**TOWN OF MOUNTAIN VILLAGE
DESIGN REVIEW BOARD REGULAR MEETING
THURSDAY MARCH 30, 2017 10:00 AM
2nd FLOOR CONFERENCE ROOM, MOUNTAIN VILLAGE TOWN HALL
455 MOUNTAIN VILLAGE BLVD, MOUNTAIN VILLAGE, COLORADO**

REVISED AGENDA

Application Overview: The purpose of this agenda item is to allow the Design Review Board (DRB) to provide initial direction to the applicant regarding a proposed new single family home.

CONCEPTUAL SITE PLAN

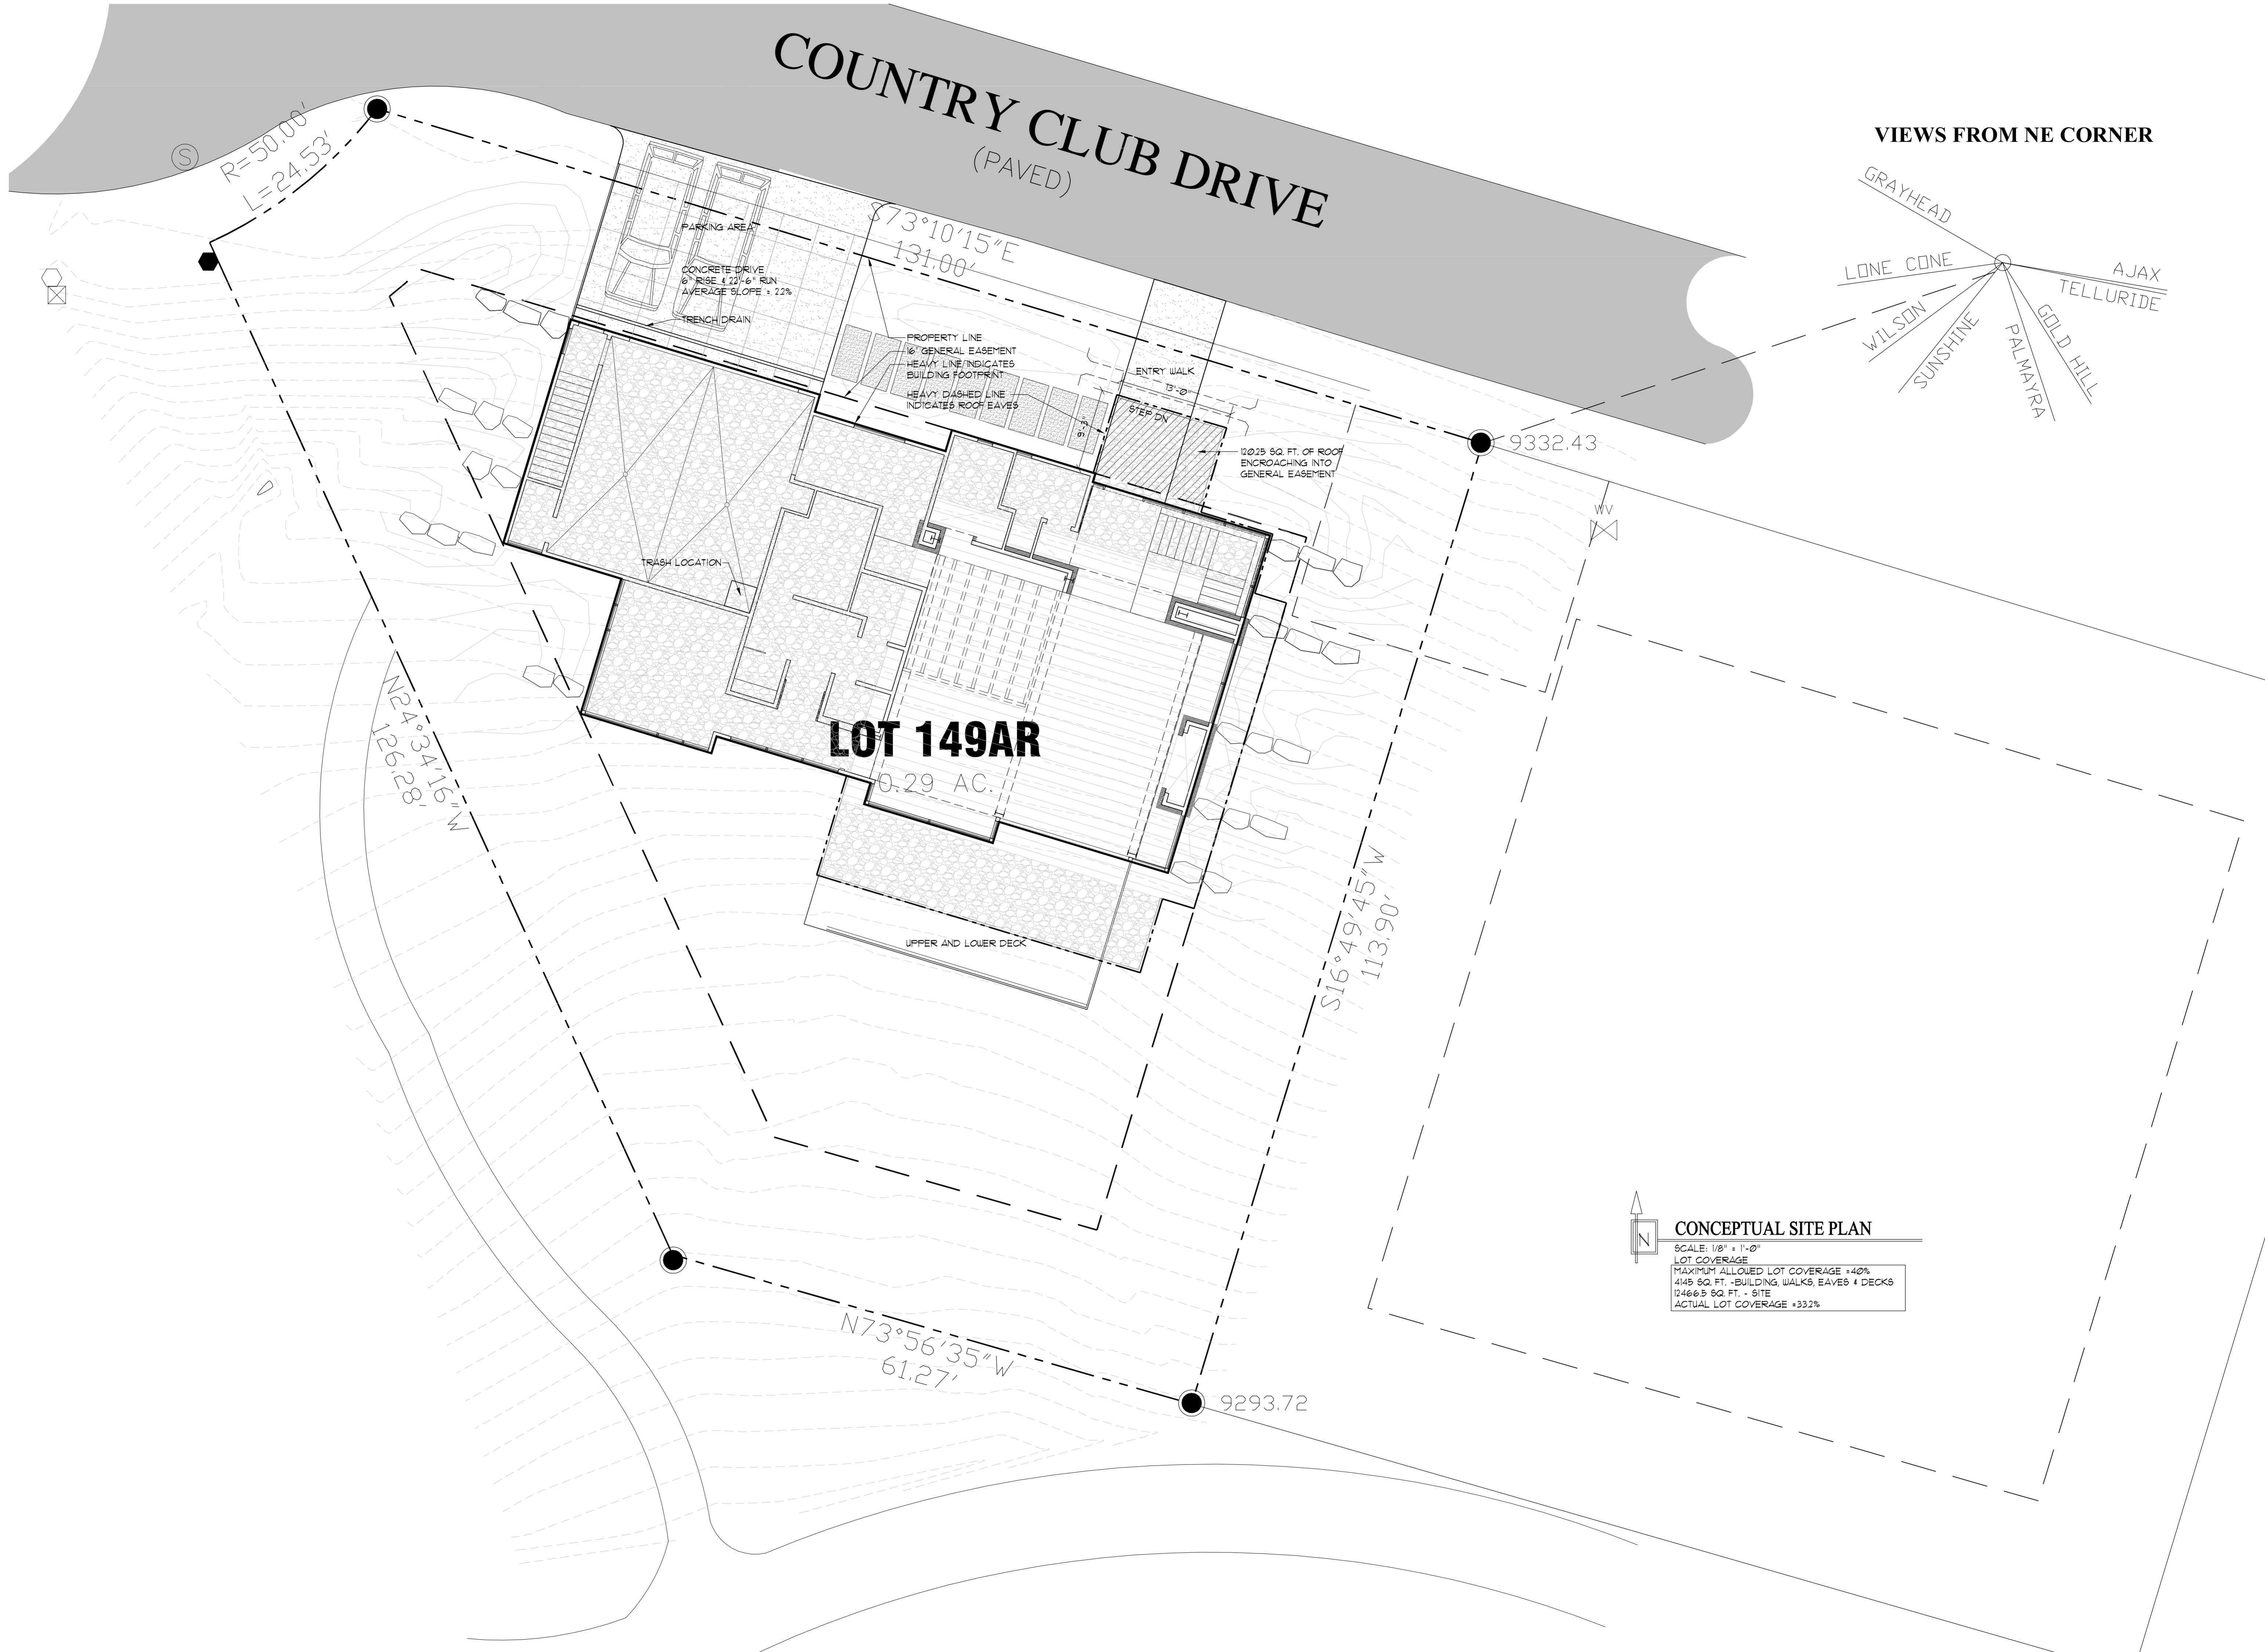
There are several proposed encroachments into the General Easement areas. The northern GE and Country Club Dr. RROW have proposed plans for an entry walkway with a culvert, a 120 square foot roof overhang for the front entryway, a paver walkway from driveway to the front entry and two exterior parking spaces that are in the GE and extend into the RROW. The western GE is showing three rock retaining walls and paver steps coming out of the ski room. The eastern GE is showing five rock retaining walls. The building footprint is out of the General Easements however it is right on the GE line and will require a footer survey prior to pouring concrete to insure no building encroachments. Public Works is in general agreement with proposed encroachments as long as they are removable improvements.

We are proposing to encroach into the 16' general easement with a roof to cover the entry walk. This roof can be seen on the C1.0 conceptual site plan. This cantilevered roof would provide basic shelter for those entering the home & keep snow off of the walkway. The proposed roof does not conflict with any utilities. See located utilities on T1.0.

46'-10"
MAXIMUM BUILDING HEIGHT

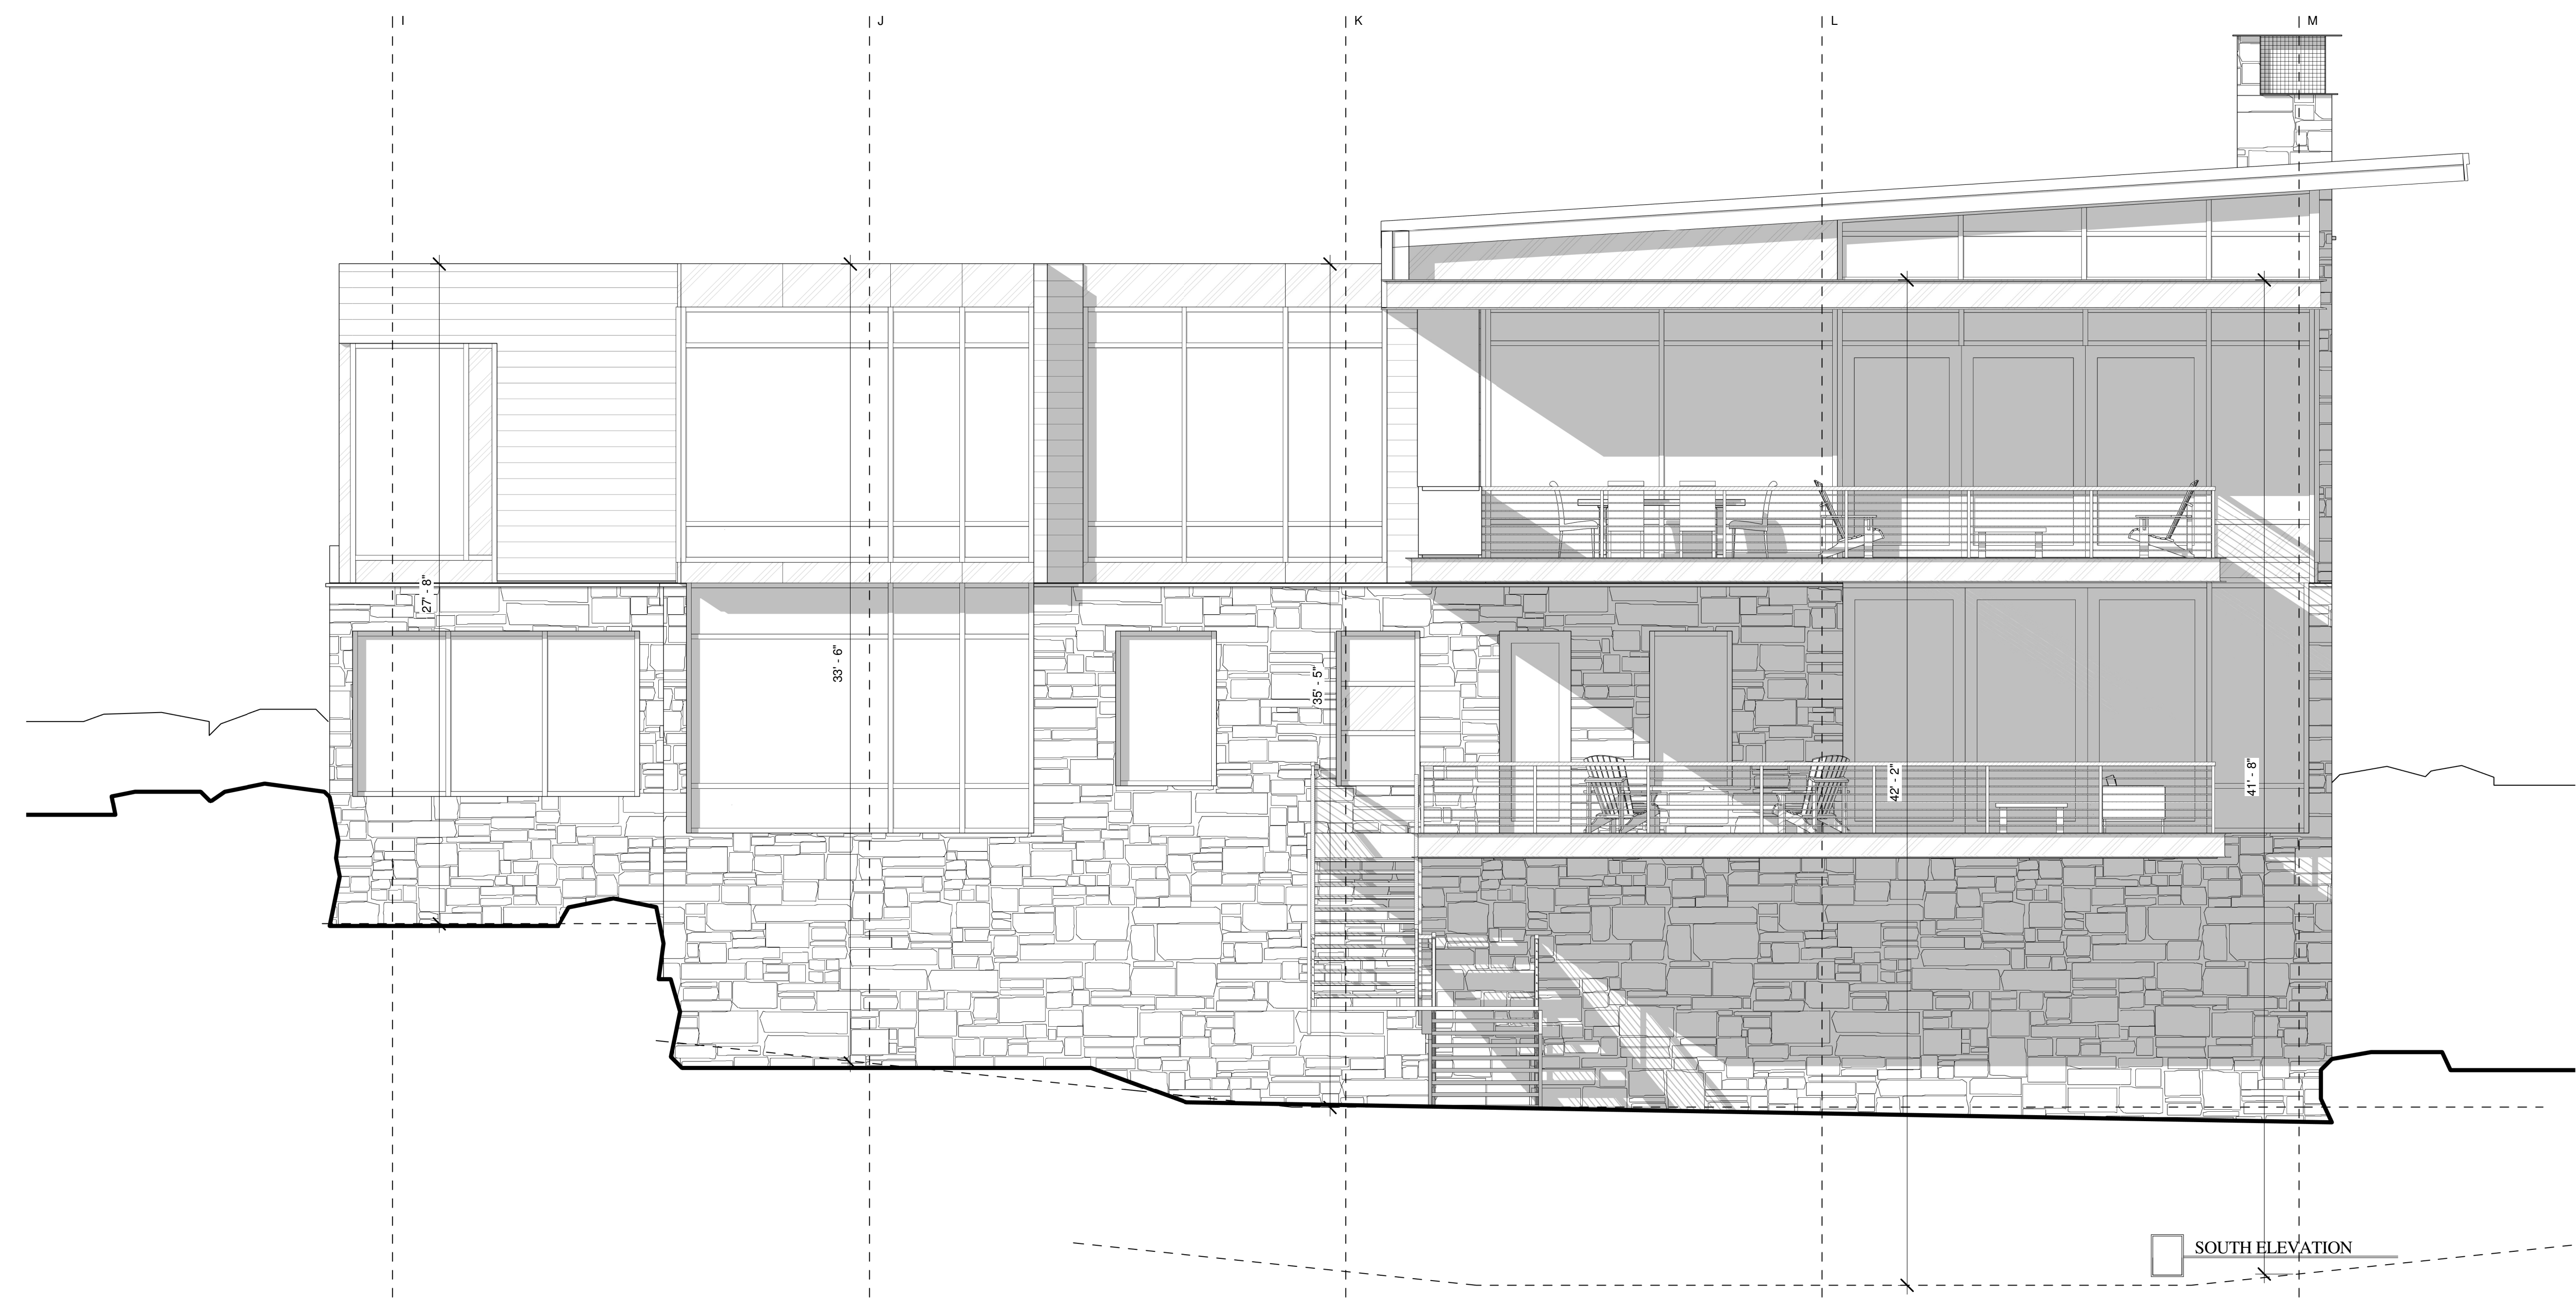
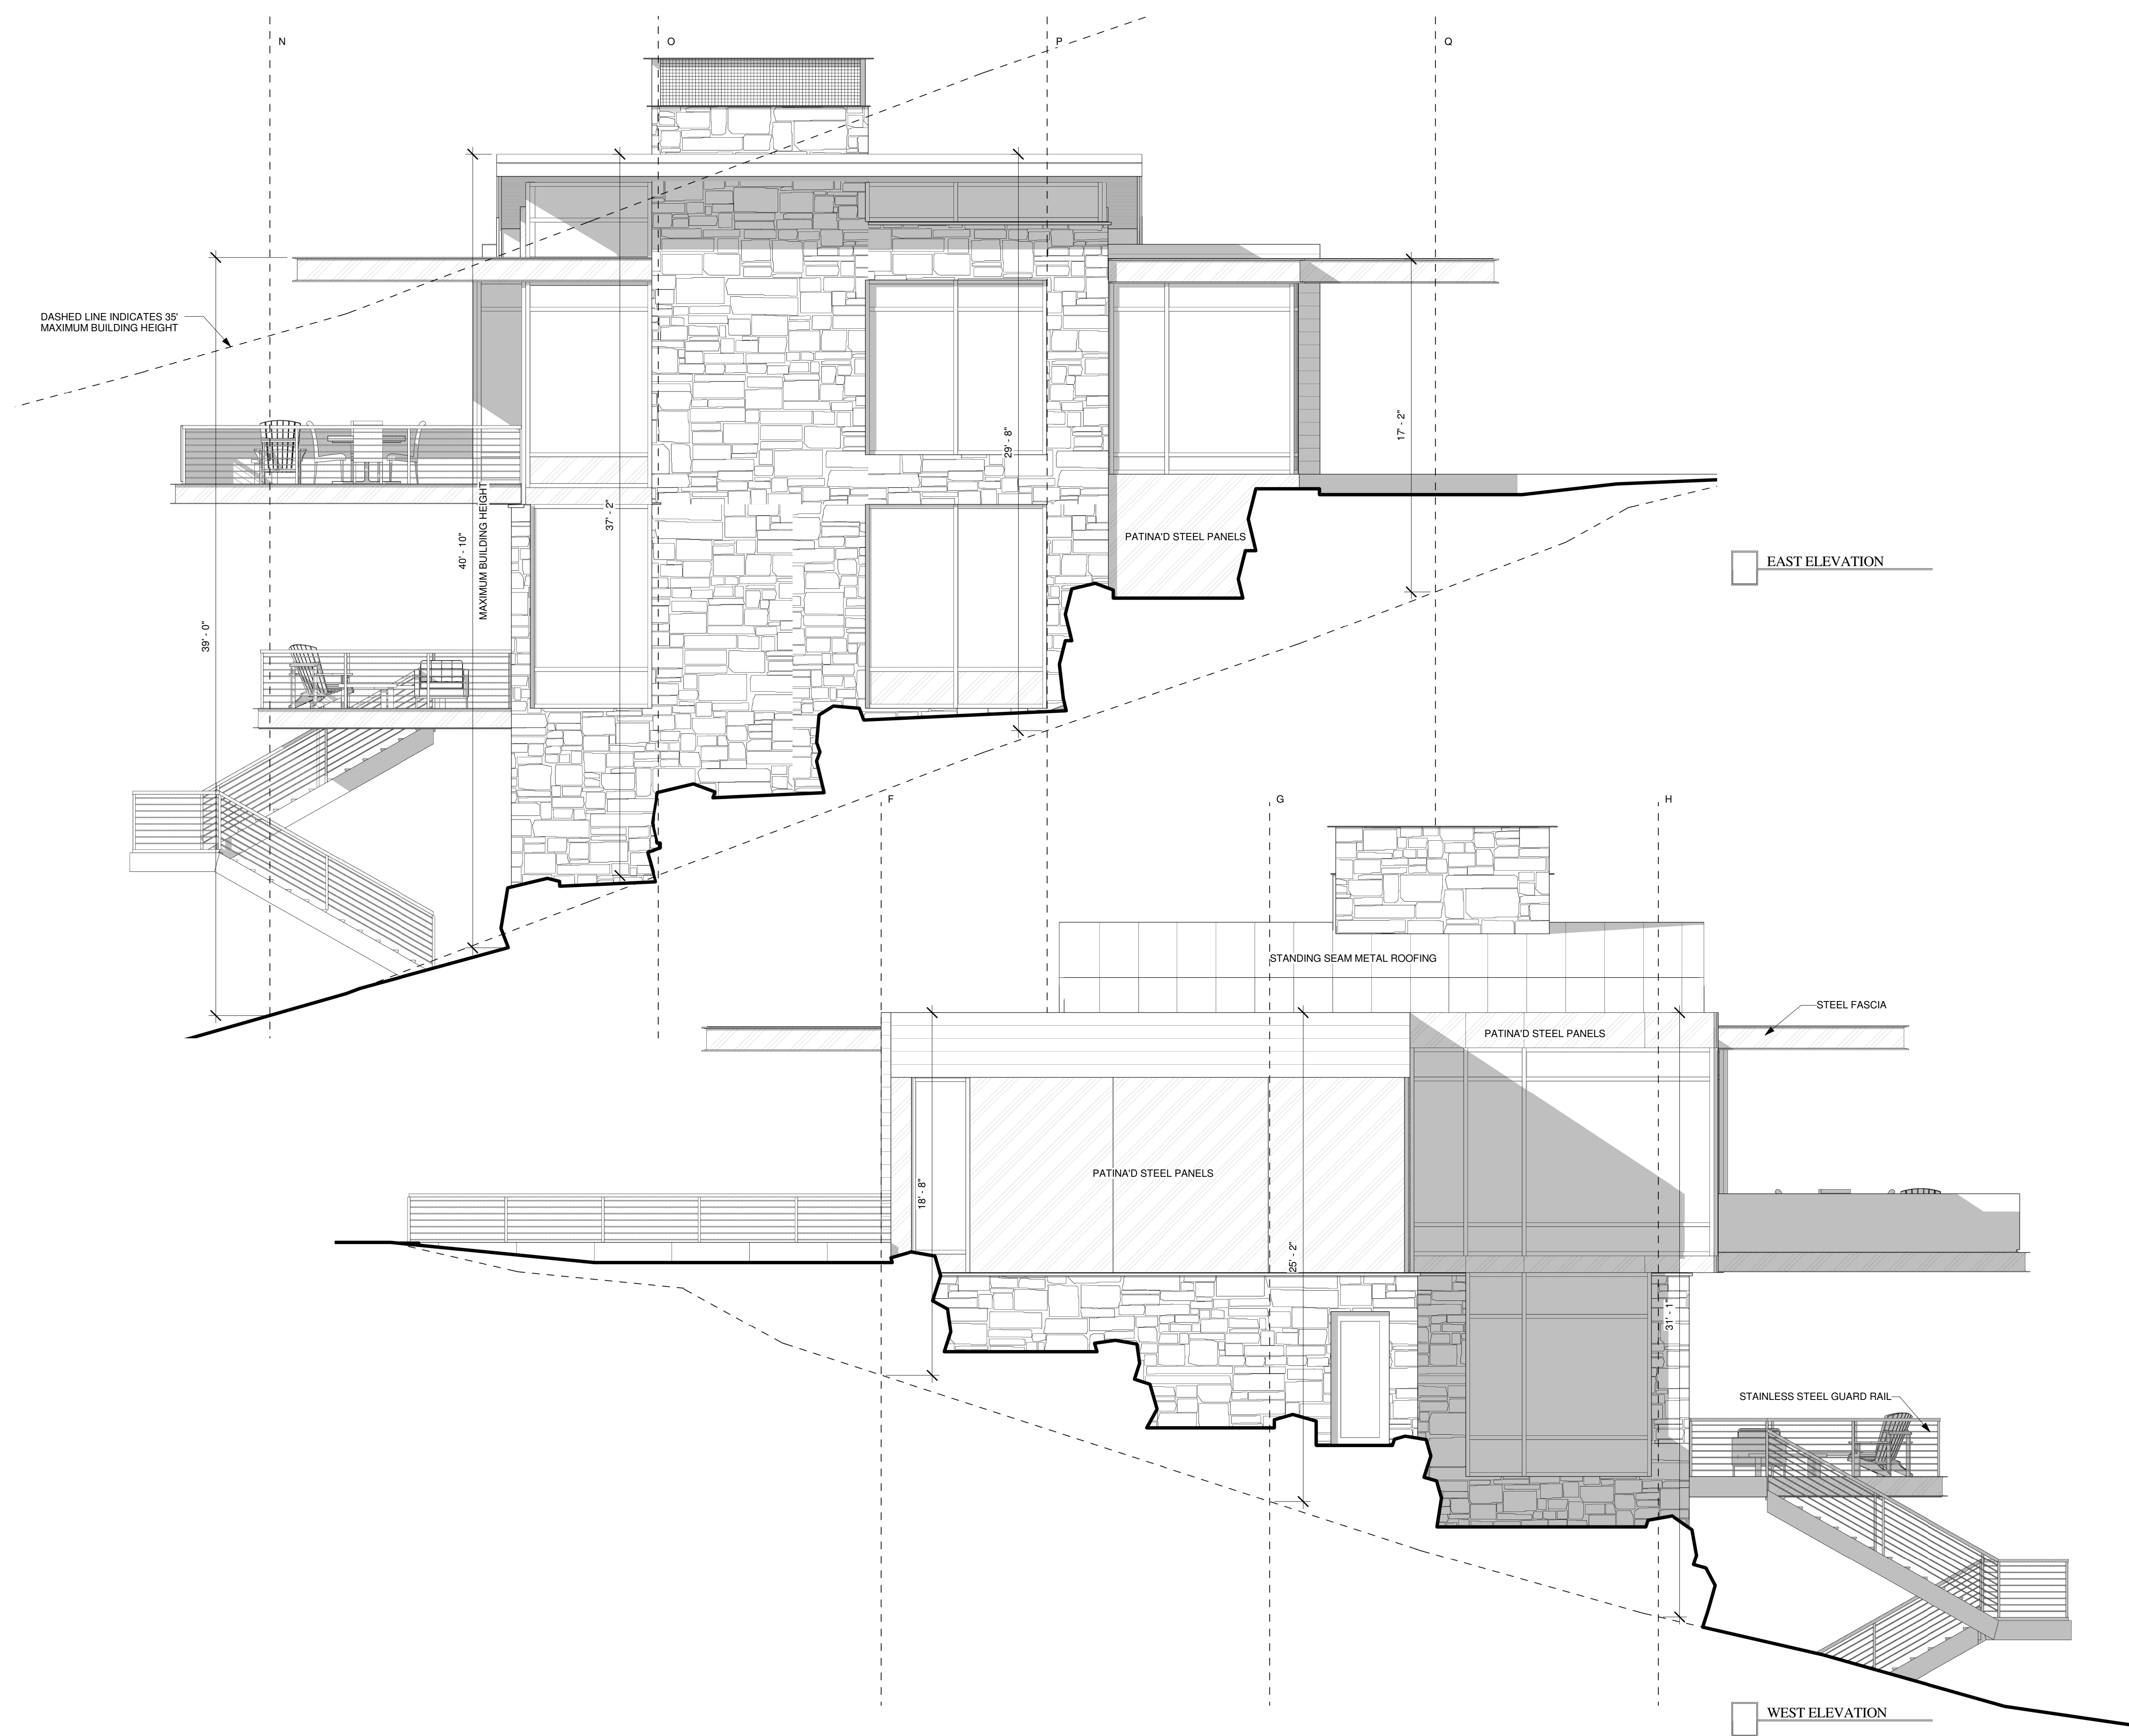
The average roof height is compliant at 27' – 9", however the maximum height is 40' – 10" which is above the maximum height and will require a variance. With primary roof being a low pitched shed, a determination will have to be made as to whether this design can extend the maximum building height up to five feet above the 35' maximum. This determination will have to be made by the Planning and Development Services Director but we would like to discuss this issue with the DRB and get your feedback and direction regarding this code issue. The determination will only have a bearing on the extent of the required variance; either 10 inches above the maximum of 40 feet or five feet ten inches (5'10") above the maximum of 35 feet".

The CDC requires the applicant to show that alternatives to meeting the height requirements result in a worse design. One alternative could be to lower the home so the driveway slope is at the maximum allowed: 5%.
